Appendix E

Agency and Council Submissions

Rix's Creek Mine Extension Project (SSD_6300) Response to exhibition of Environmental Impact Statement

Rix's Creek Extension project (SSD 13_6300) Response to exhibition of Environmental Impact Statement DPI Water – Detailed Comments

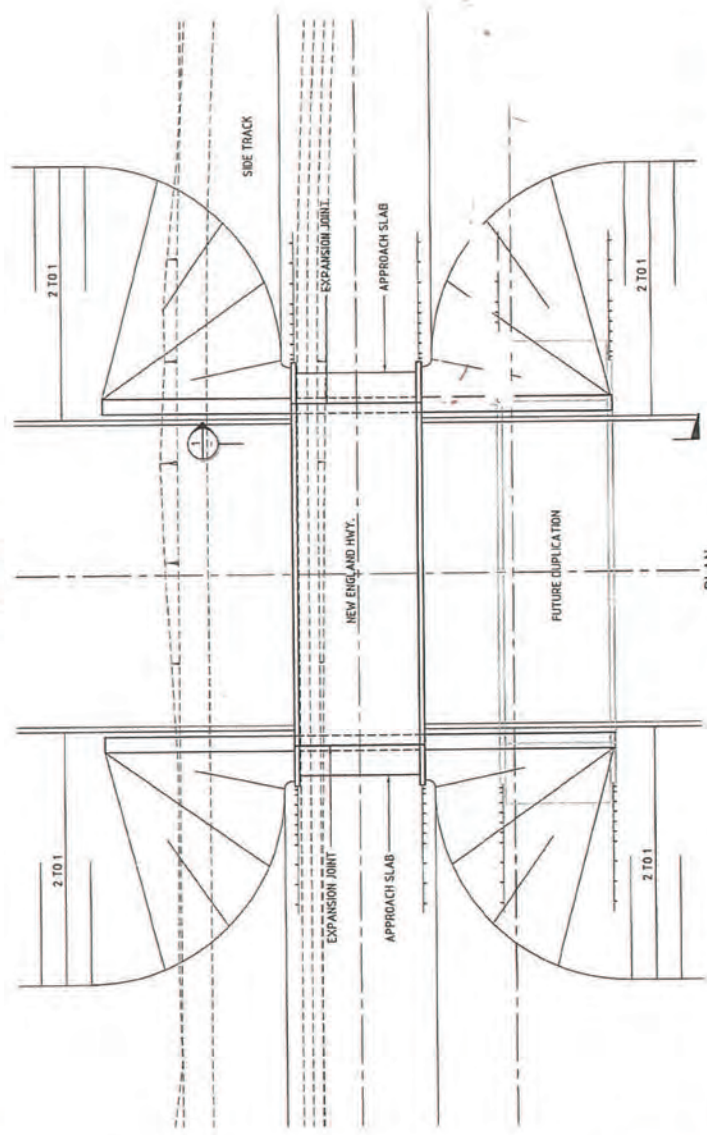
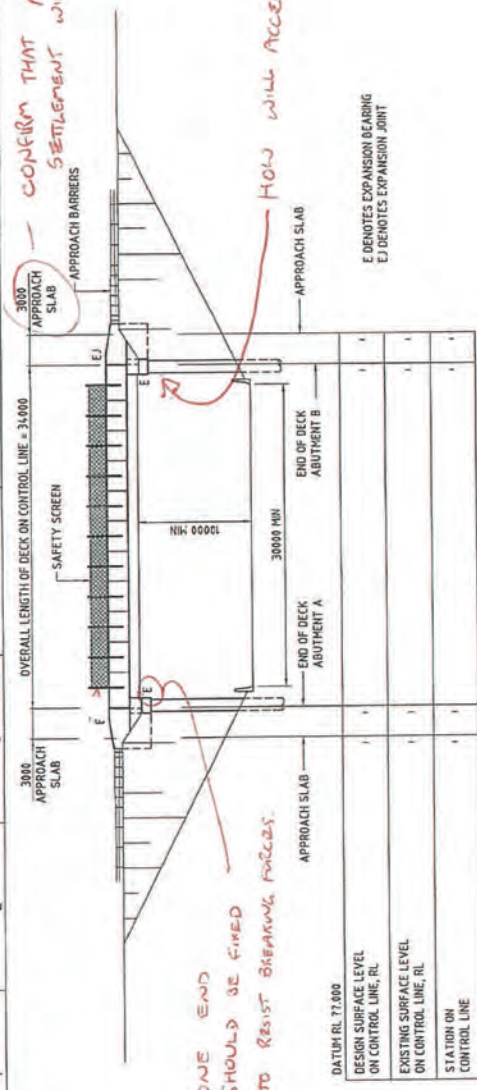
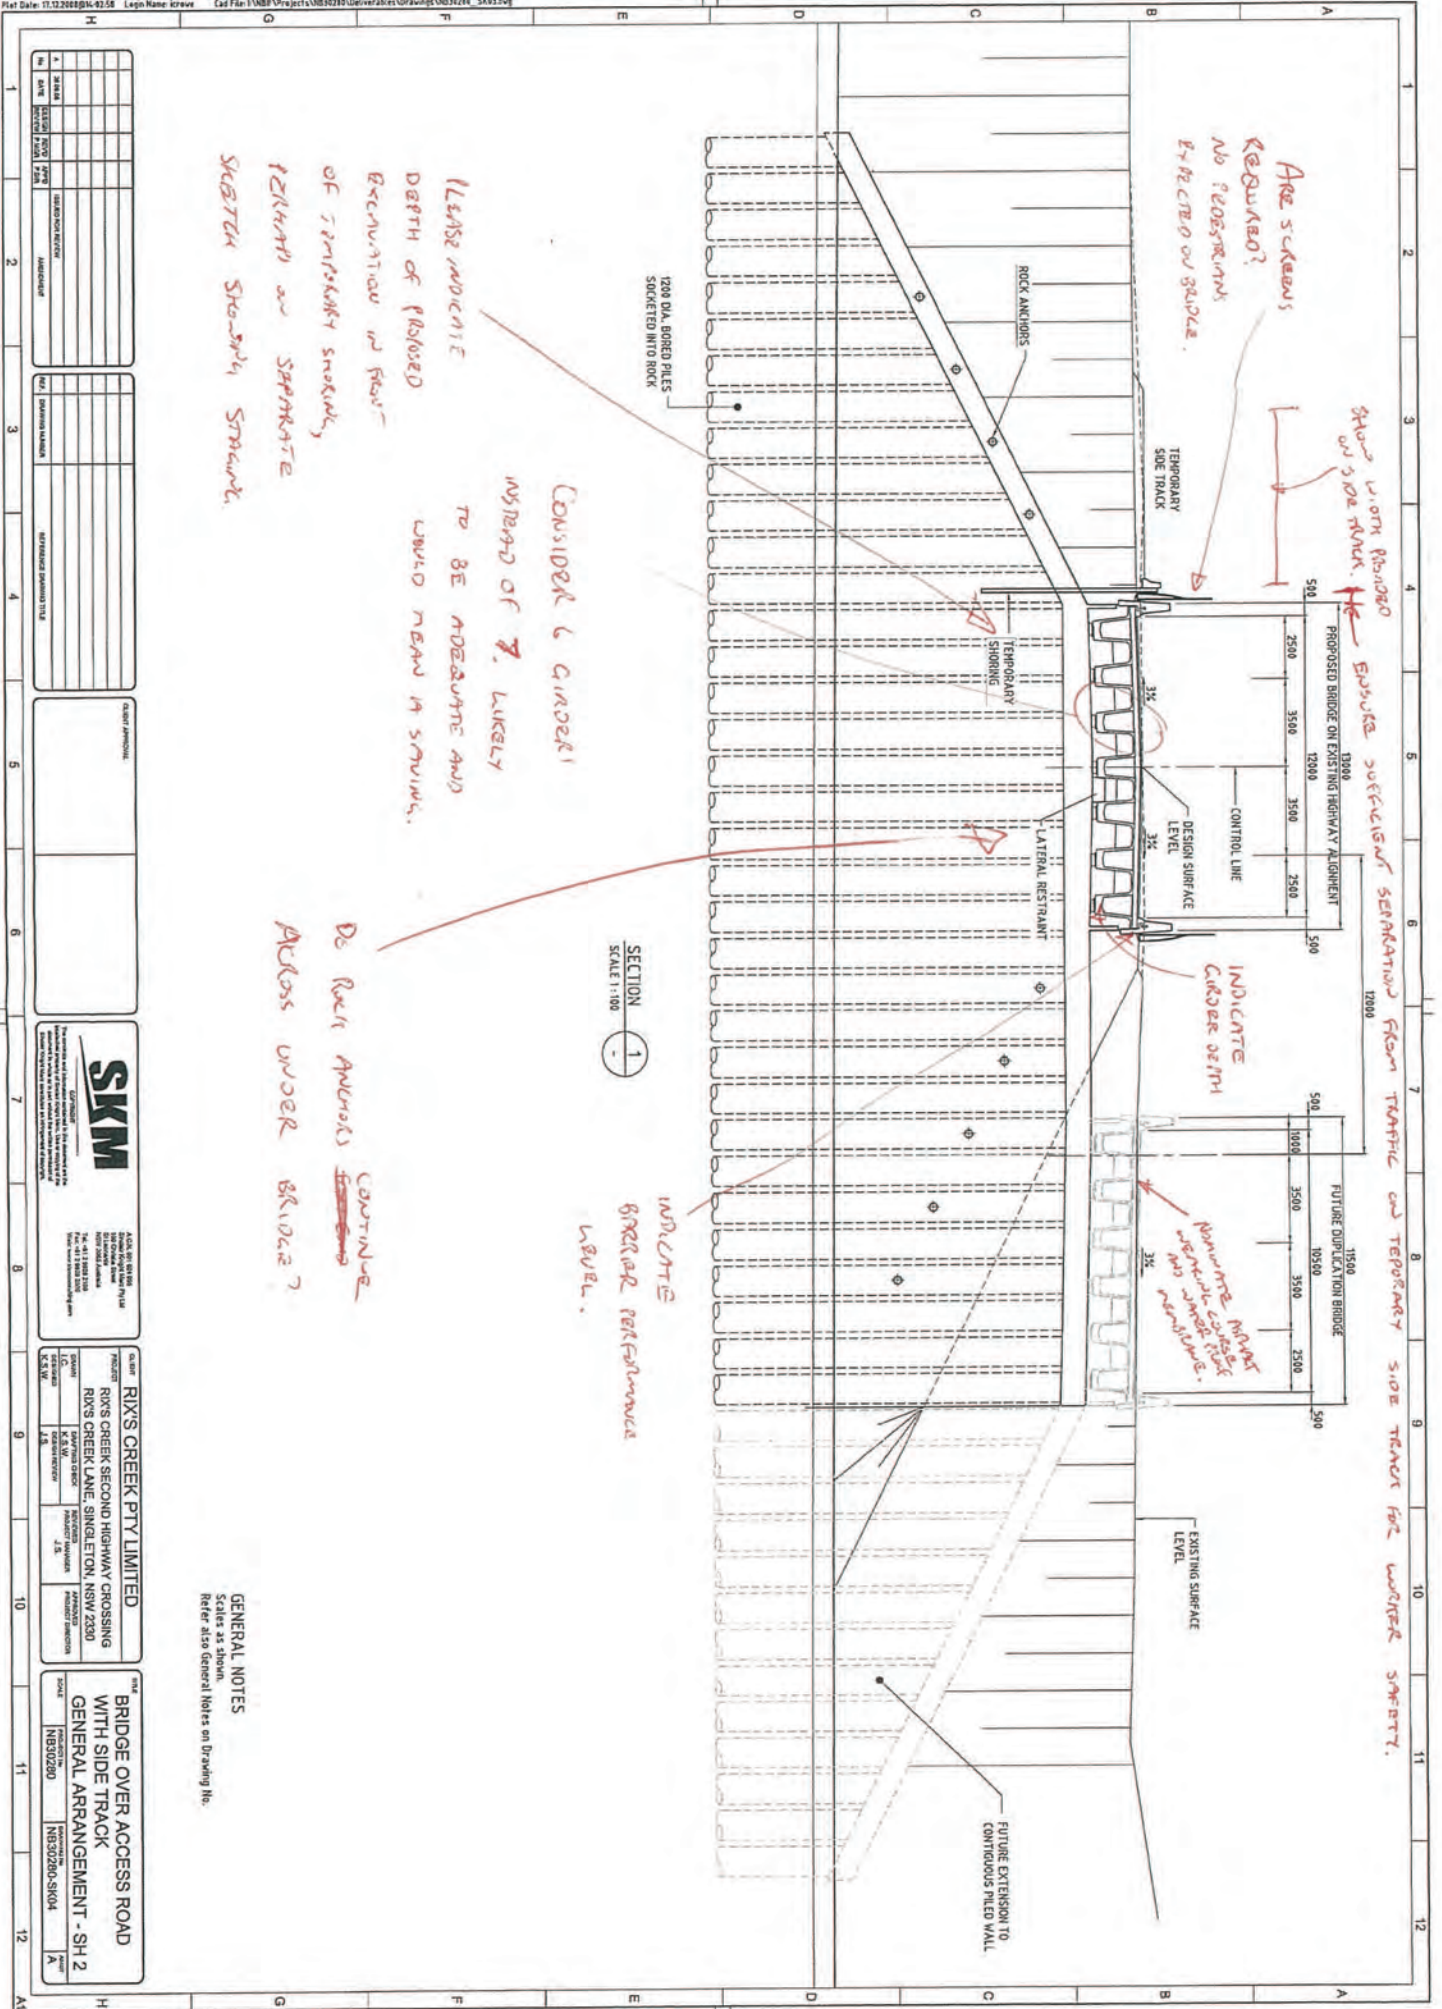
- All structures on the Roads and Maritime network, especially on highways, shall be designed in accordance with the AS5100 Bridge Design code, as well as RMS specifications, Bridge Technical Directions, and standard drawings.
- The Cut and Cover Tunnel Concept Design included in Appendix E of the EIS shall be amended to incorporate comments provided by Roads and Maritime, as per the marked-up plans attached.

- * BRIDGE DESIGN SHOULD CONFORM TO RMS BRIDGE TECHNICAL DIRECTIONS AND STANDARD DRAWINGS.

* Show location of

FIBRE OPTIC CABLE ON
